### **STAFF REPORT**

**CSPA 86-C-029-09**

# Dulles Corner Comprehensive Sign Plan Amendment

CSPA-86-C-029-9

FRONT VIEW:

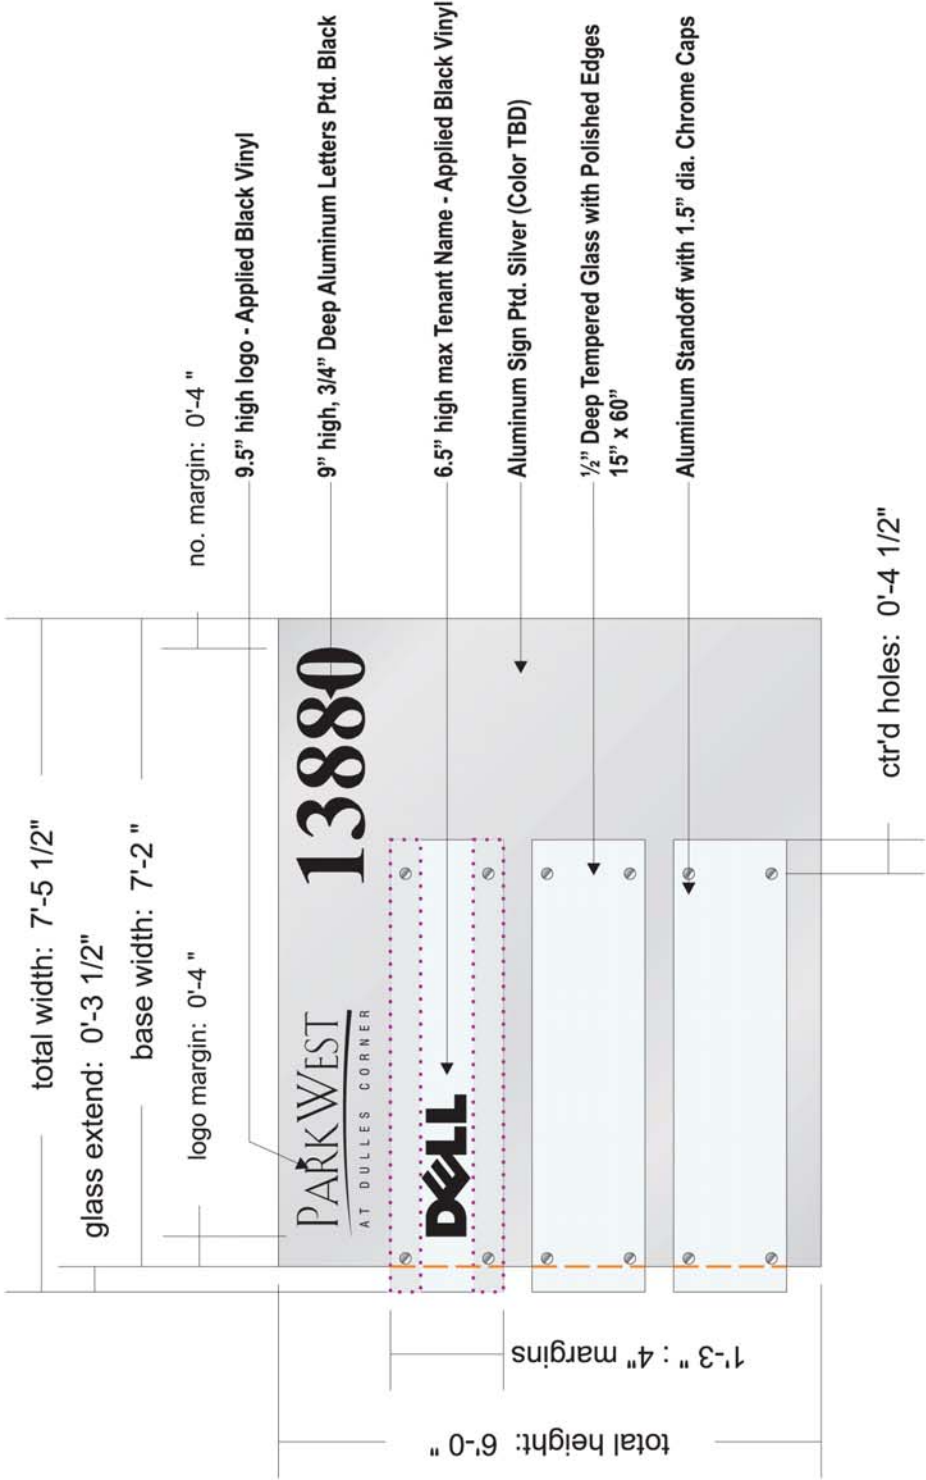
While the proposed sign exceeds the permitted sizing criteria in Section 12-203-13.B. of the Zoning Ordinance, staff recognizes the ability of the Planning Commission to exercise flexibility in this regard as a function of the Comprehensive Sign Plan process.

4. The location of the new freestanding sign needs to be illustrated on a full sized site plan.
5. The new proposed freestanding sign does not state if the sign is to be externally or internally illuminated. If illuminated, a separate electrical permit will be required per the National Electrical Code.
